TROWBRIDGE HSBC

Facade Survey

Monday 13 May 2024

Henley Restoration And Remedials Ltd For ISG

EAST ELEVATION

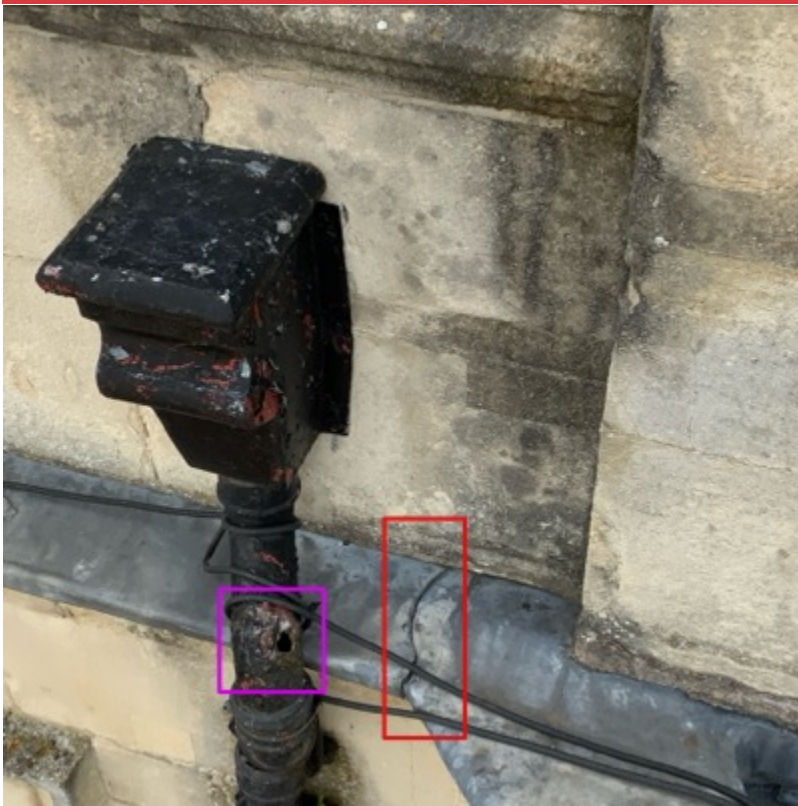
1.2 - Allow to remove fixings across the facade and point up. 2nr seen currently.

EAST ELEVATION

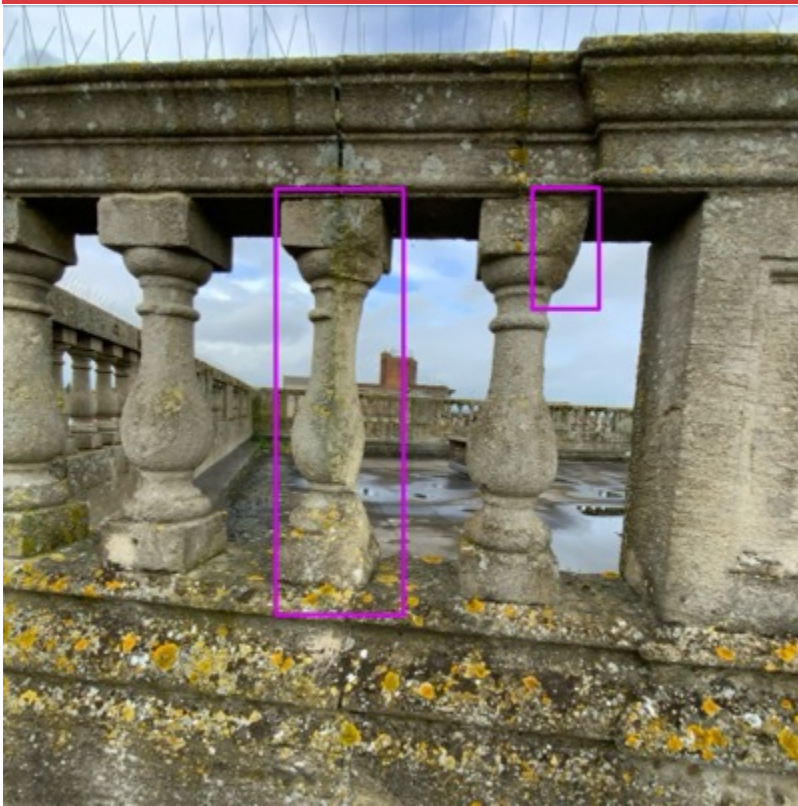
3.24 - Allow to pin and repair around down pipe socket fixing.

WEST ELEVATION

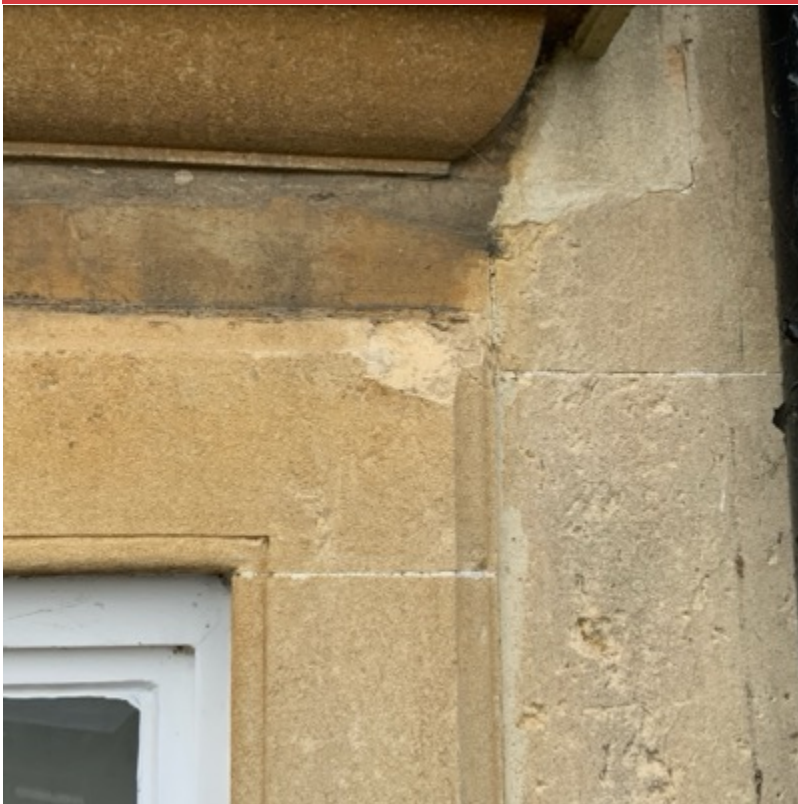
1.5 - Allow to indent with matching stone new section of lower frieze to the upper cornice.

Allow 0.580 x 0.090 x 0.090 (joint to joint)

WEST ELEVATION

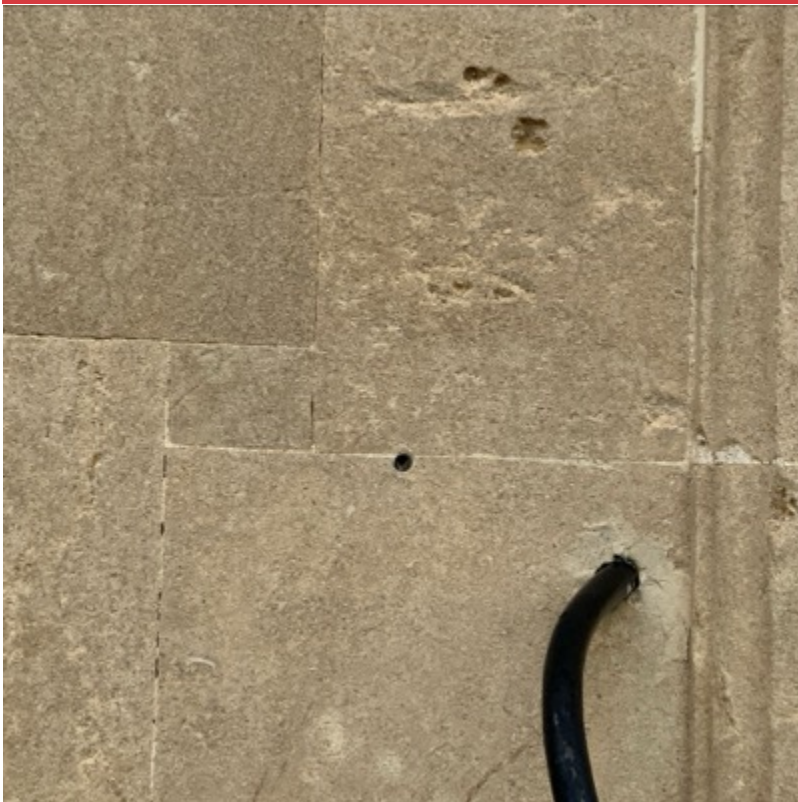
2.3 - Allow to indent new stones above "blind" window.

Allow 0.225 x 0.190 x 0.050

Allow 0.260 x 0.100 x 0.050

WEST ELEVATION

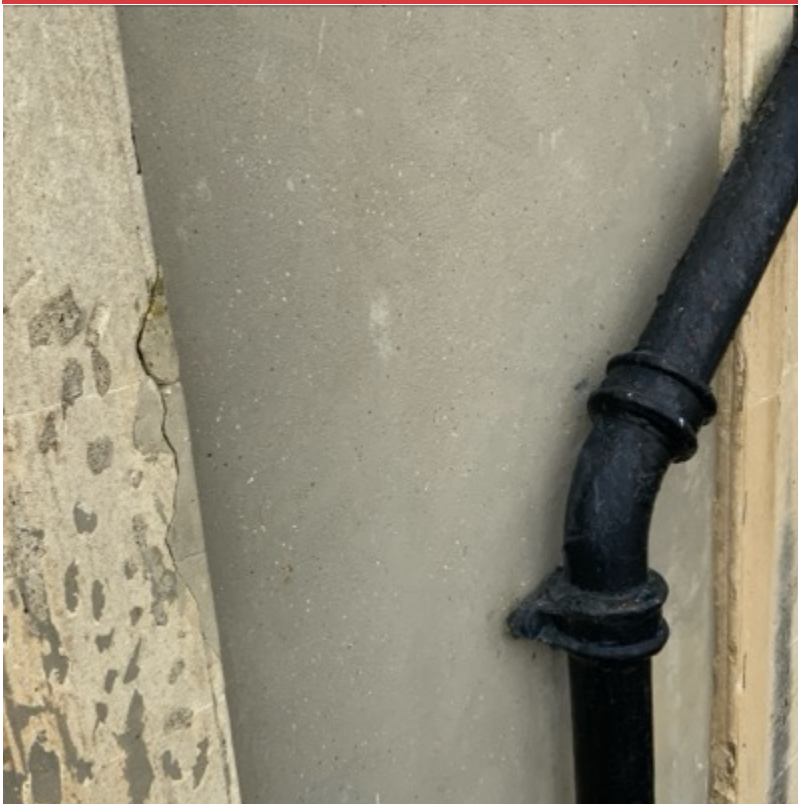
2.8 - Allow to indent with new stone LHS blind window. Allow 0.550 x 0.220 x 0.060

WEST ELEVATION

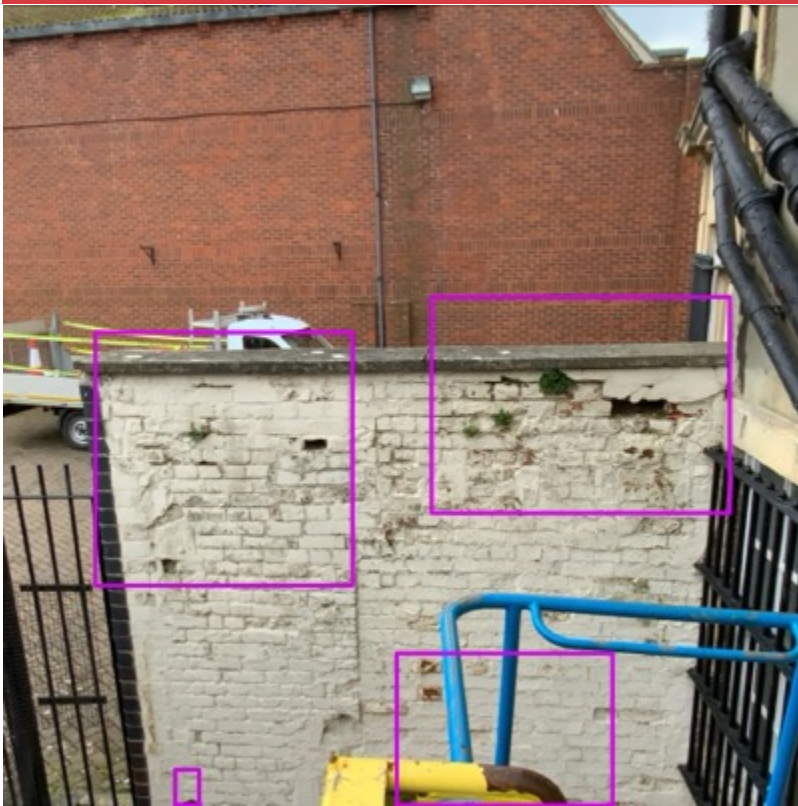
3.2 - Allow to defrass/remove loose and cracked stone and previous repairs and carry out mortar repair.

Allow 0.100 x 0.050 x 0.025.

Allow 0.150 x 0.150 x 0.025 x 10nr
around metal window guard.

NORTH ELEVATION

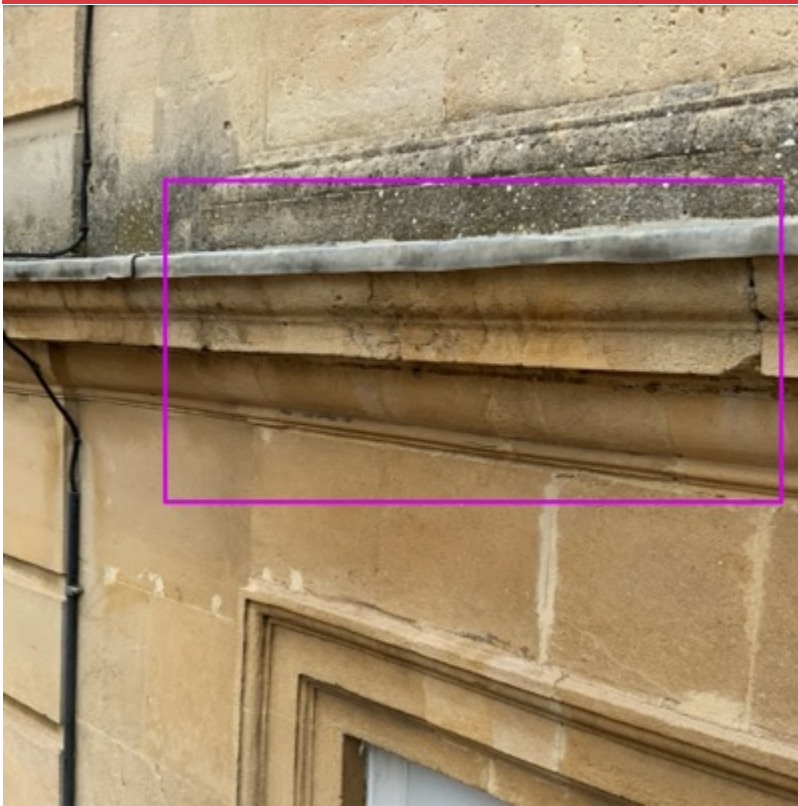
2.1 - Allow to indent frieze drip detail to 2nd floor cornice.

Allow 0.250 x 0.050 x 0.075 allow 2nr.
